**RE: Sawmill Tract H, 1921 Bellamah Ave. NW**  
**Grading & Drainage Plan**  
**Engineer's Stamp Date: 3/23/2023**  
**Hydrology File: J13D017B**

**RE: SAWMILL TRACT H, 1921 BELLAMAH AVE. NW  
GRADING & DRAINAGE PLAN  
HYDROLOGY RESPONSE TO COMMENT**

1921 BELLAMAH AVE NW ALBUQUERQUE, NM	DRAWN BY pm
	GRADING PLAN	DATE 3-23-23
	 5571 MIDWAY PARK PL NE ALBUQUERQUE, NEW MEXICO 87109 (505) 858-3100 www.tierrowestllc.com	SHEET # GR-1
		JOB # 2022047

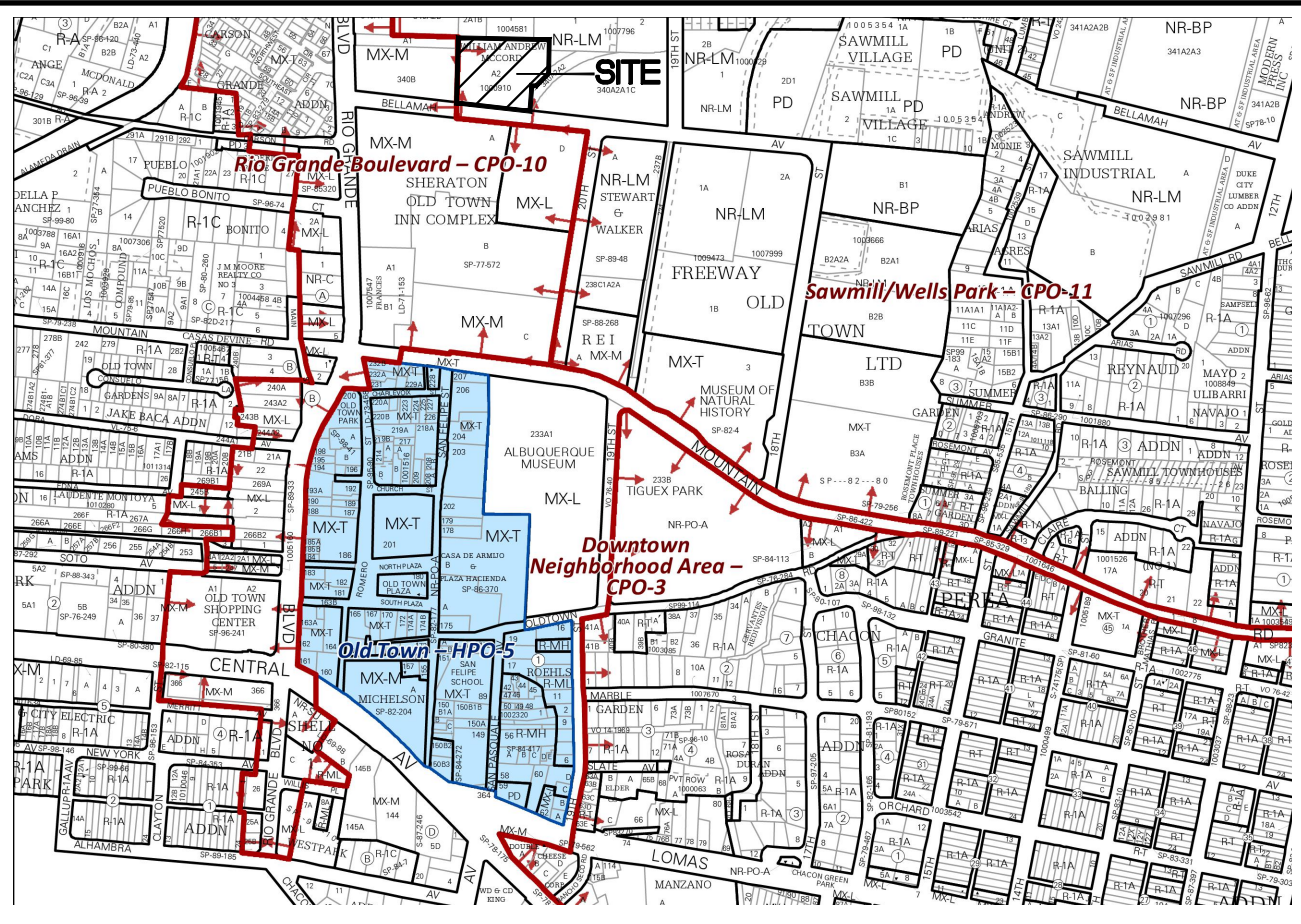
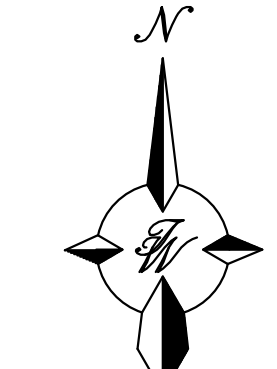
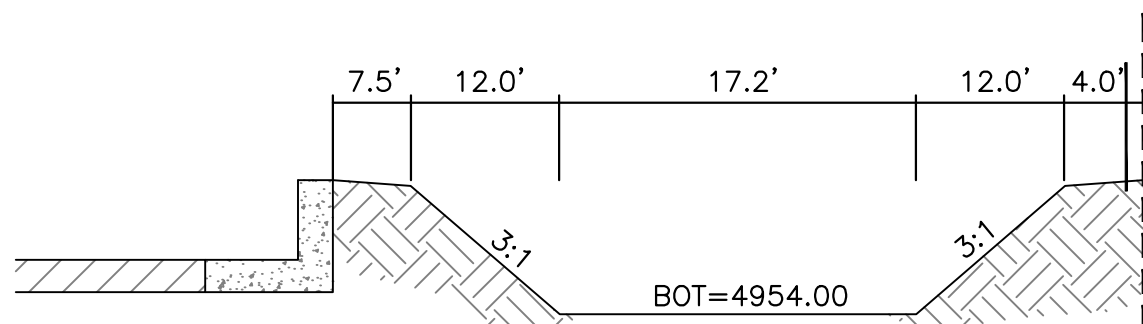
1. Please provide pond 2 location, volume, and cross-section on sheet #GR-1.  
**That was a left over sentence from a previous concept. That paragraph was removed and the narrative updated to reflect the current drainage.**

2. Show the bioswale for proposed basin 1.  
**The bioswale is along the north property line and is now labeled.**
3. On sheet #GR-1, Proposed Drainage: It states that "The pond in basin 2 will retain the developed runoff of 0.036 ac-ft which is less than the required water quality volume of 0.40 ac-ft". – This statement is confusing. First of all, the retention pond volume should not be less than the SWQV. Secondly, would pond 1 volume be counted for part of the SWQV? Please clarify. Also, the required SWQV is 0.04 ac-ft, not 0.40 ac-ft. This might be a typo.

**The narrative was updated to provide a clearer picture of the drainage and calculations**
4. On the same sheet: The next sentence states that "The pond will drain 7.15 cfs. Therefore the total discharge from the site will be 8.09 cfs". – Please provide calculations showing that where these numbers come from.
